Decision Date: April 4, 2017

RE: Vesting Tentative Tract Map No. VTT-74684
Related Cases: N/A
Address: 1118-1128 ½ North Avenue 56
Community Plan: Northeast Los Angeles
Zone: RD1.5-1
Council District: 14 - Huizar
CEQA No.: ENV-2016-4404-CE

VESTING TENTATIVE TRACT MAP NO. 74684

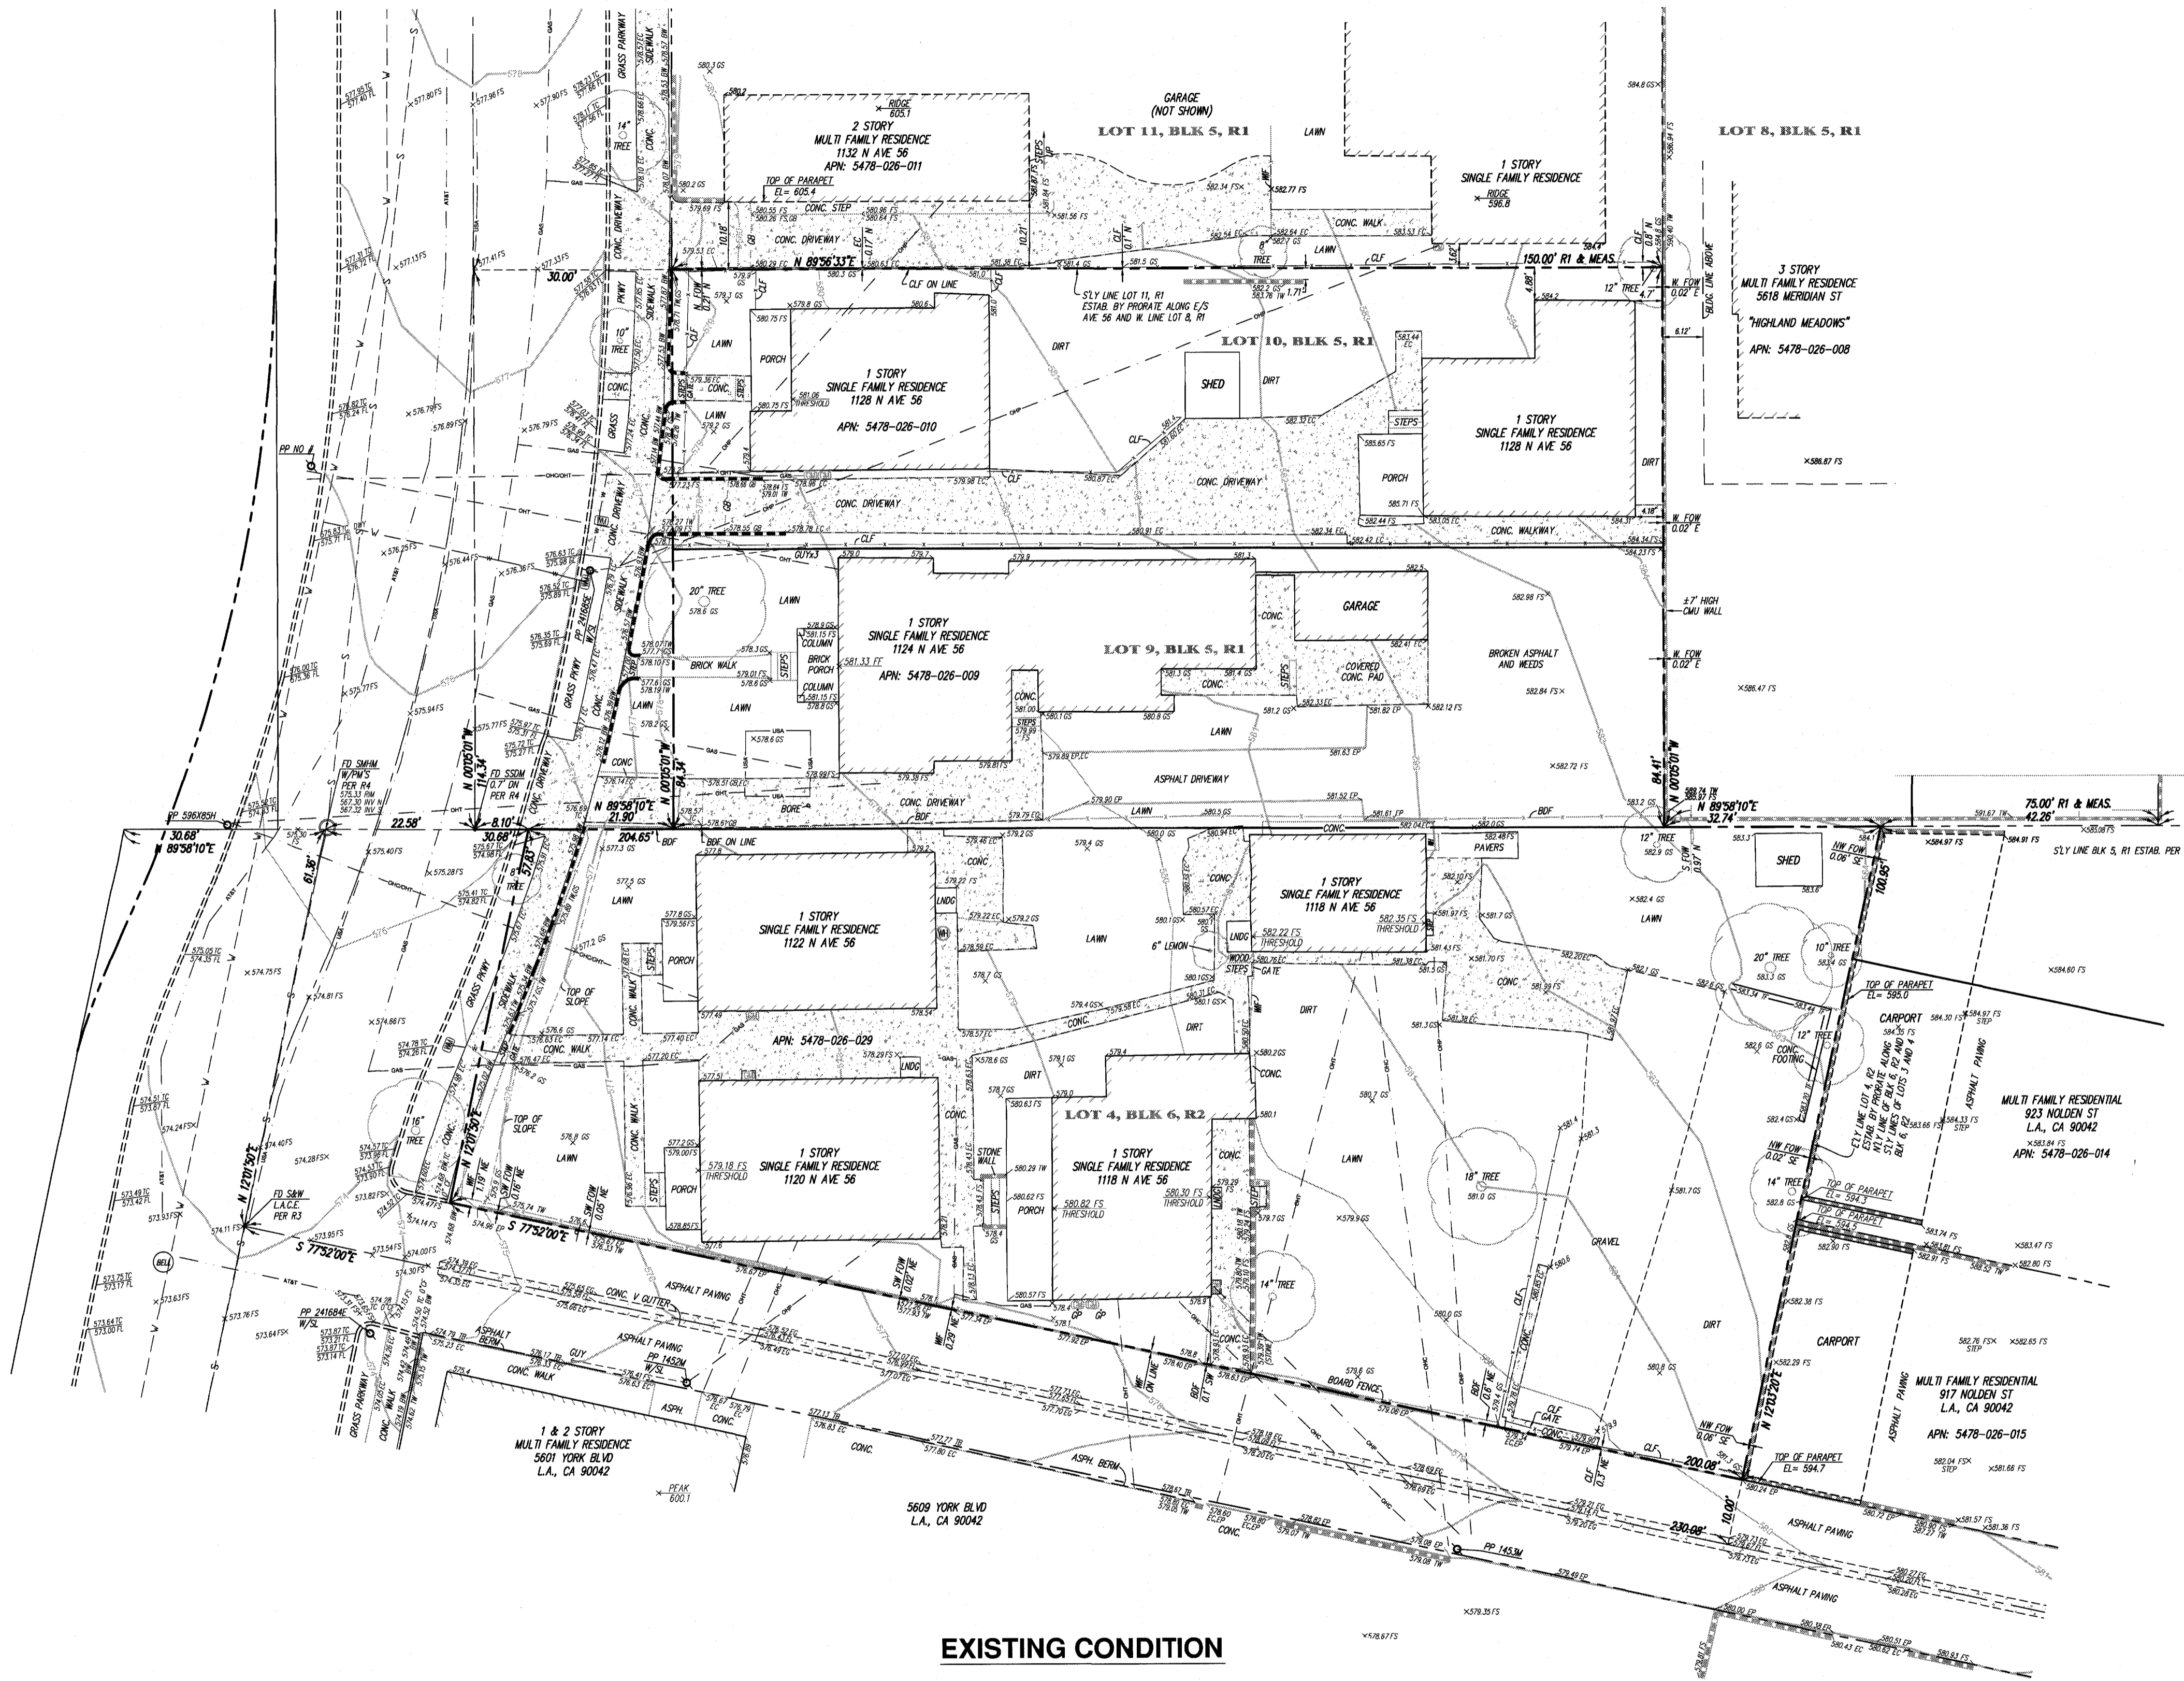
1. That a variable width strip of land be dedicated along Avenue 56 adjoining the subdivision to complete a 30-foot wide half public street right-of-way measured from the Avenue 56 centerline.

3. That if Department of Transportation has no objection to the merger, then portion of the Avenue 56 as shown on the vesting tentative map stamp dated November 17, 2016 in excess of 30-foot measured from the center line of the Avenue 56 be permitted to be merged with the remainder of the tract map pursuant to Section 66499.20.2 of the State Government Code, and in addition, the following conditions be executed by the applicant and administered by the City Engineer:

- b. Lots 1, and 11 do not comply with the minimum 15 ft. front yard setback along Avenue 56 after required street dedication is taken as required for the **RD1.5 Zone**. Revise the Map to show compliance with the above requirement or obtain approval from the Department of City Planning for the setbacks indicated in the Setback Matrix.

- c. Lots 11 to 17 do not comply with the minimum 6 ft. side yard setback for a three stories building along the alley as required for the **RD1.5 Zone**. For a building more than two stories in height, one foot shall be added to the width of such side yard for each additional story above the second story. Revise the Map to show compliance with the above requirement or obtain approval from the Department of City Planning for the setbacks indicated in the Setback Matrix.

- d. Resubmit the map to provide and maintain a minimum 20 ft. common access strip open to the sky for Lots 12 to 20 all the way to the public street for frontage purpose per Section 12.03 under the definition of "Lot". No projections are allowed into the 20 ft. minimum common access strip. Provide the 20 ft. wide common access open to the sky all the way to the public street or obtain approval from the City Planning Advisory Agency to allow a reduced common access strip all the way to the public street.

- e. Resubmit the map to provide and maintain a minimum 20 ft. common access strip open to the sky for Lots 17 to 20 for vehicular access purpose per Section 12.03 under the definition of "Lot" all the way to the alley. No projections are allowed into the 20 ft. minimum common access strip. Provide the 20 ft. wide common access open to the sky or obtain approval from the City Planning Advisory Agency to allow a 12 ft. reduced common access strip all the way to the alley.

- f. Show all street dedications as required by Bureau of Engineering and provide net lot area after all dedications. "Area" requirements shall be re-checked as per net lot area after street dedication. Front yard requirements shall be required to comply with current code as measured from new property lines after dedication.

- g. Provide and dimension the reciprocal private easement for driveway egress and ingress in the final map.

Note to City Zoning Engineer and Plan Check. The Advisory Agency has considered the following setbacks in conjunction with the approved map. Minor deviations to the map's setbacks are allowed in the event that such deviations are necessary in order to accommodate other conditions of approval as required by other City agencies. In no event shall the setback from the perimeter boundary of the subdivision measure less than 5 feet in width, pursuant to LAMC Section 12.22-C,27:

Setbacks				
Lot No.	Front	North Side	South Side	Rear
1	5.1'	5'	7.7'	5'
2	5'	5'	7.7'	0'
3	0'	5'	7.7'	3.1'
4	3.1'	5'	7.7'	0'
5	0'	5'	7.7'	5'
6	0'	12.7'	2.2'	7'
7	3.1'	12.7'	29.8'	0'
8	0'	12.7'	22.6'	3.1'
9	3.1'	12.7'	16.6'	0'
10	5.1'	12.7'	4.7'	3.1'
11	5.7'	5.3'	5'	0'
12	0'	8.8'	5'	0'
13	0'	8.8'	5'	0'
14	0'	8.8'	5'	0'
15	0'	8.8'	5'	0'
16	0'	8.8'	5'	7.5'
17	3'	0'	5'	5'
18	14.3'	0'	0'	5'

19	20.8'	0'	0'	5'
20	24.4'	5'	0'	5'

- 2) A minimum 5-foot common access strip open to the sky be provided for pedestrian ingress and egress on the final map all the way from the public street to Lots 12 through 20 for frontage purposes per LAMC Section 12.03.
 - 3) The common access driveway may maintain a minimum width of 12 feet , clear to the sky as shown on the map stamped dated November 17, 2016.
22. Prior to the clearance of any tract map conditions, the applicant shall show proof that all fees have been paid to the Department of City Planning, Expedited Processing Section.
23. Indemnification and Reimbursement of Litigation Costs.
